SUBDIVISION REPORT - CONCEPT/DEVELOPMENT PLAN

▶ **FILE #:** 12-SD-23-C
12-D-23-DP

▶ **SUBDIVISION:** FRETZ ROAD SUBDIVISION

CONCEPT PLAN
PLANNING FILE NUMBERS: 12-SD-23-C/12-D-23-DP

CO.00

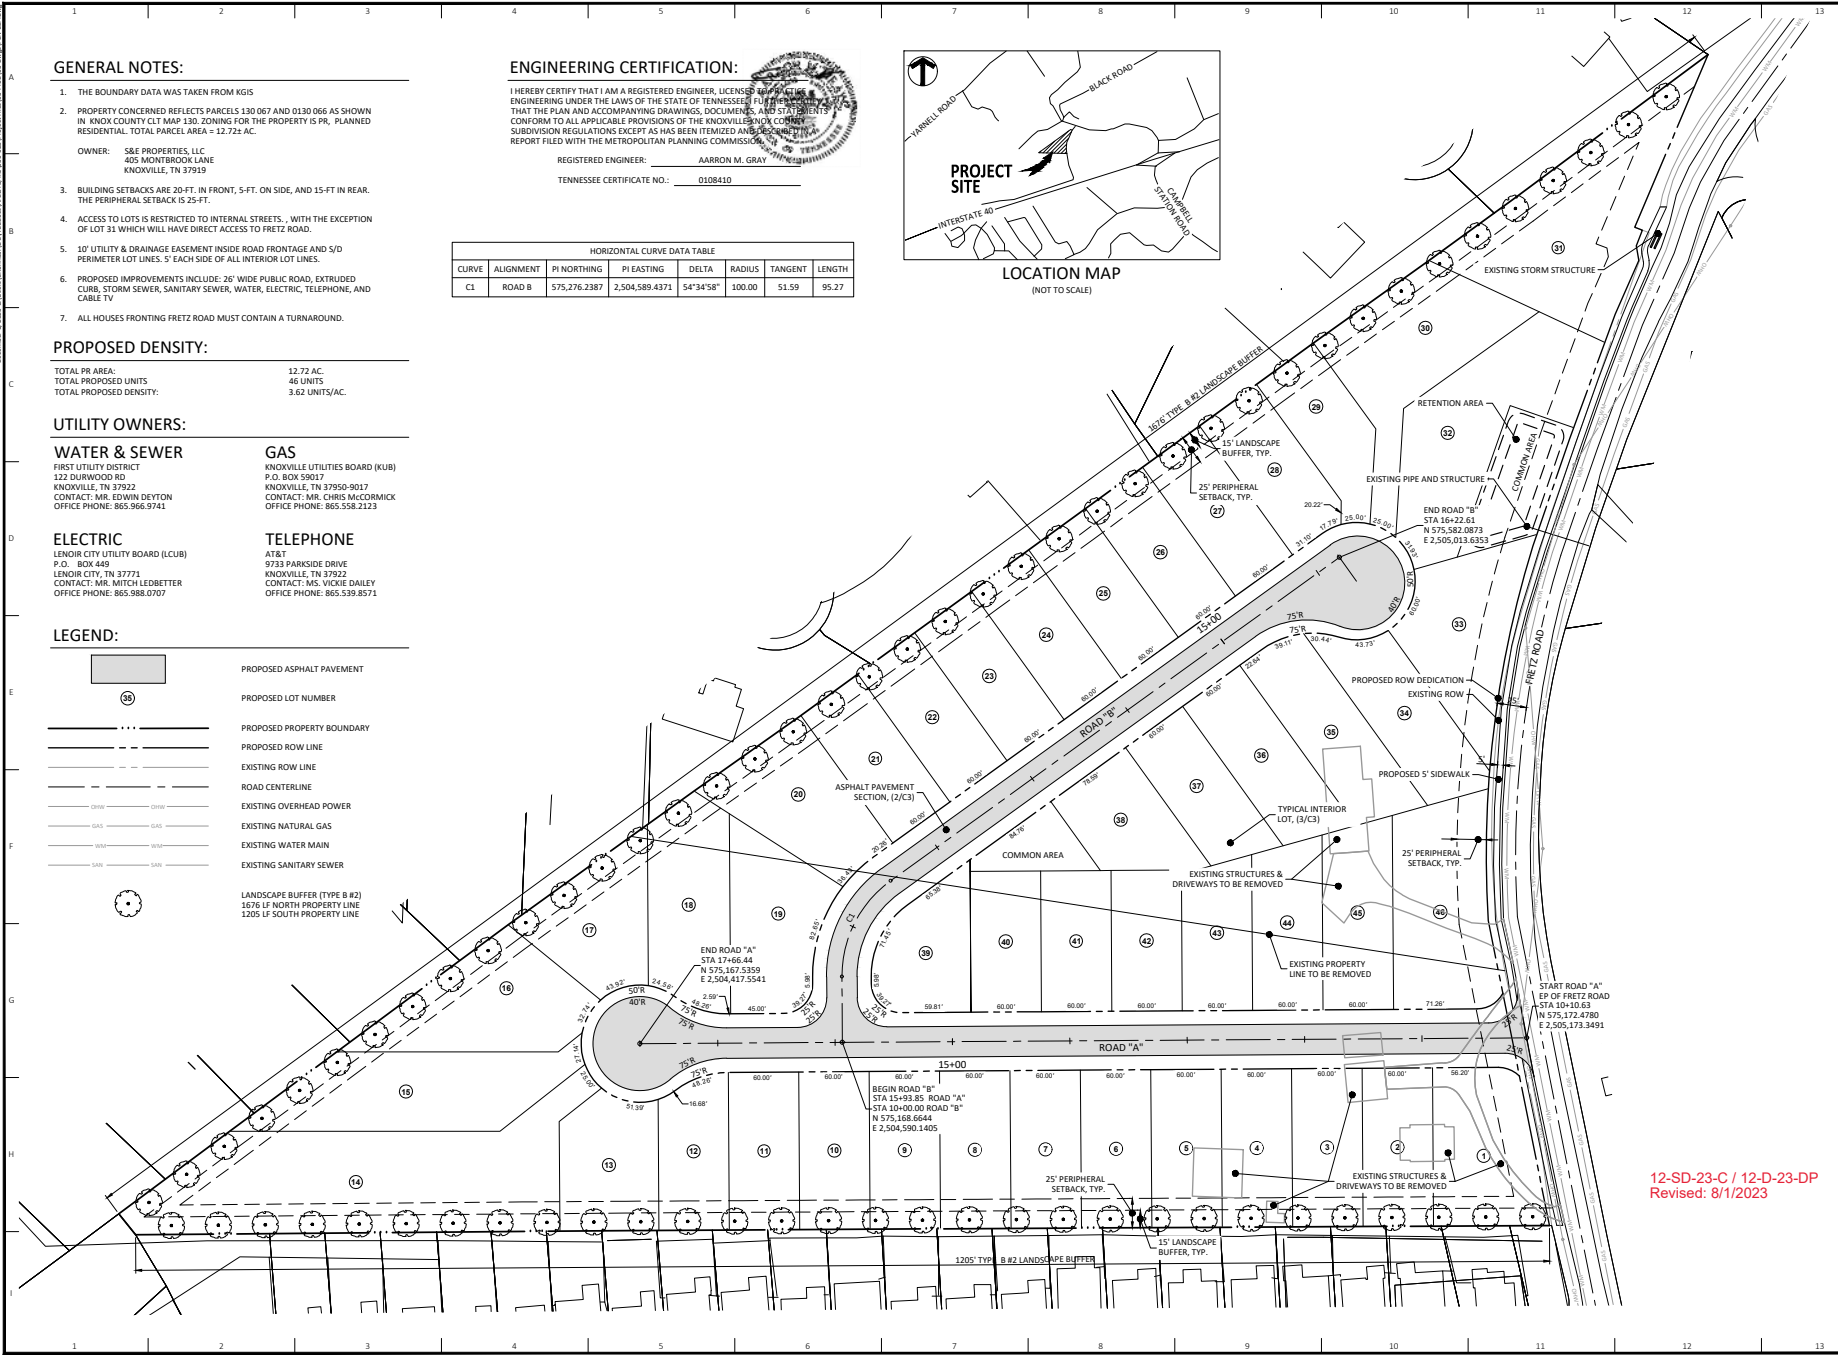
4) All access strips must have a minimum width of 25 ft for the entire depth, measured at a 90-degree angle to the parallel lot lines of the access strip.

9) Providing a note on the final plat that lot 31 shall have an on-site vehicle turnaround if access is provided from Fretz Road.

10) All double frontage lots must meet the requirements of Section 3.02.A.4. of the Subdivision Regulations.

The concept plan shows the location of two potential sinkholes and the required 50-ft buffer. The applicant submitted a "report of limited geotechnical exploration" that must be reviewed and approved by Knox County Engineering and Public Works during the design plan phase. If either of these are determined to be a sinkhole, the uppermost contour line of the sinkhole and the 50-ft buffer must be shown on the final plat. Any proposed lots that do not have buildable area outside of the sinkhole must be eliminated or combined with other lots with buildable area. Any structures proposed within a 50-ft sinkhole buffer must have foundations designed by a registered engineer. No structures are allowed within a sinkhole (closed contour) identified on the final plat.

The concept plan shows where the Type B landscape screening is required. The landscape shown is not representative of the actual number of trees and spacing recommended by the Type B landscape screening guidelines. The landscape plan is required to be reviewed and approved by Planning staff during the design plan phase and before clearing and grading commence on the site if concept plan condition # 2 is approved as recommended.

The applicant is requesting a reduction of the 35-ft peripheral setback to 25 ft on all external boundaries of the development. A 25-ft peripheral setback was approved by the Planning Commission for the Brandywine at Turkey Creek subdivision to the south. There are four lots in the Ridgeland subdivision, located in the Town of Farragut, with structures that are close to the northwest boundary of the subject development. The proposed lots that adjoin the Ridgeland subdivision are approximately 130 ft deep and will have a Type B landscape screen along this boundary per the zoning condition.

2) The peripheral setback along the Fretz Road frontage shall be a minimum of 50 ft from the centerline of Fretz Road.
